FST2XT Software Change History

Issued by: NEW Lift Steuerungsbau GmbH

Release: FST V0183, 03.04.2024

8) Hydraulic Rail Clamping:

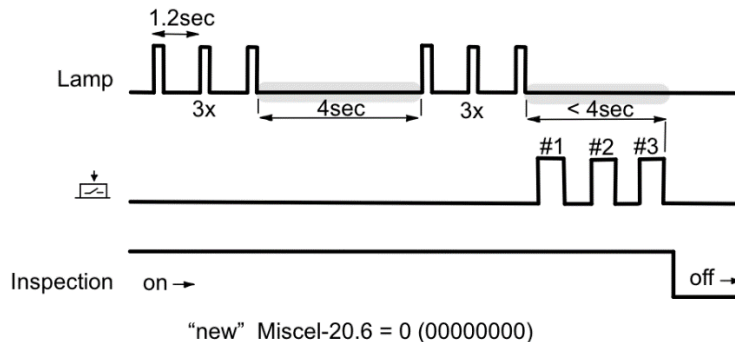
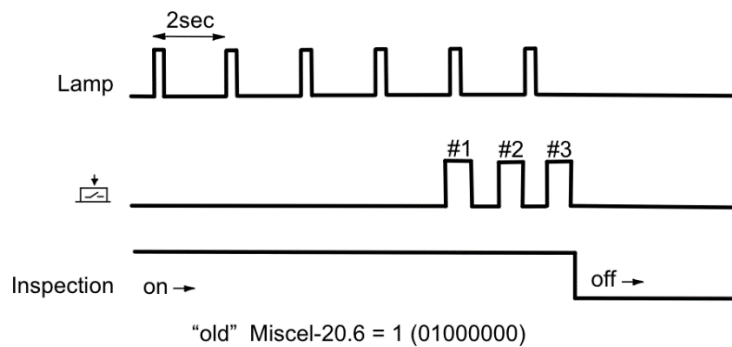
for the automatic lift-rope tensioning mode (FST V0173), the maximum (fixed) operating wait time has been extended from 3 to 8 seconds.
